Notice about the of measurement value error

We have found a possibility that the power phase angle measurement may become the out of accuracy specifications on the 15MS/S INPUT UNIT U7005.

Figure 1: Comparison of the phase error caused by this failure and accuracy specification

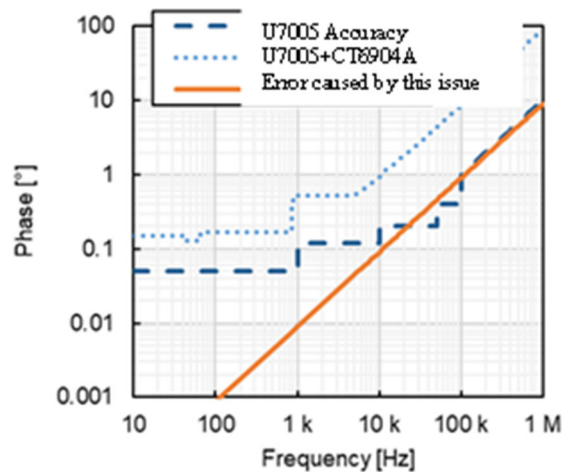
On the U7005, the power phase angle measurement error is occasionally increased when turning on the power, and it may become out of the accuracy specifications at about 20kHz or higher.

However, if it is used with the current sensors (actual use), the measurement error remains within the accuracy specifications of the total accuracy of the U7005 and current sensors even if the failure occurs.

The Figure 1 in below shows the typical example of measurement error of this failure, accuracy specifications of the U7005 itself, and accuracy specifications when using with the AC/DC CURRENT SENSOR CT6904A.

Rewriting the component data in the U7005 at free of charge. (It is not possible to rewrite by a customer, because it requires the adjustment and inspection after rewriting the data after disassembling the U7005.)
